From: Anna Williams
Sent: 23/08/2022 4:49:14 PM
To: Council Northernbeaches Mailbox; Stephanie Gelder
Cc: Brett Duell; [REDACTED]
Subject: Submission objecting to 38 The Drive Freshwater DA2022/1128
Attachments: Draft Submission 9 Lodge Lane for 38 The Drive.pdf;

RE: DA2022/1128 New Dwelling at 38 The Drive Freshwater

Figure 3: Ground levels below the sitting room and ensuite are below RL45.7 indicating a height breach.
Source: Excerpt from lower ground level plan **sketchArc**

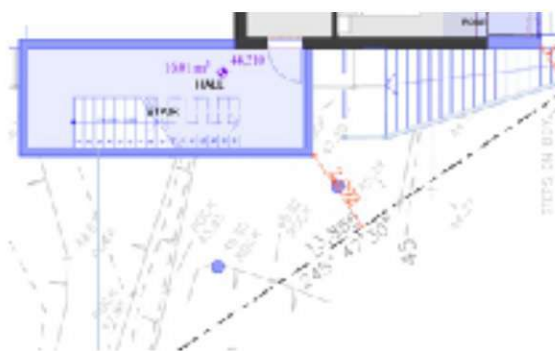
Again, we cannot agree with the applicants position that the non-compliance is limited to the north east corners of the front decks. Examining the survey levels in the vicinity of the piers supporting the first floor sitting room and ensuite area, it is apparent that the ground lines are below RL 45.7, and therefore the structure above these levels which is at RL54.2 will be breaching the height limit. The location of the piers and the immediate ground levels surrounding these locations are shown on the below excerpt from the applicant's lower floor plan.
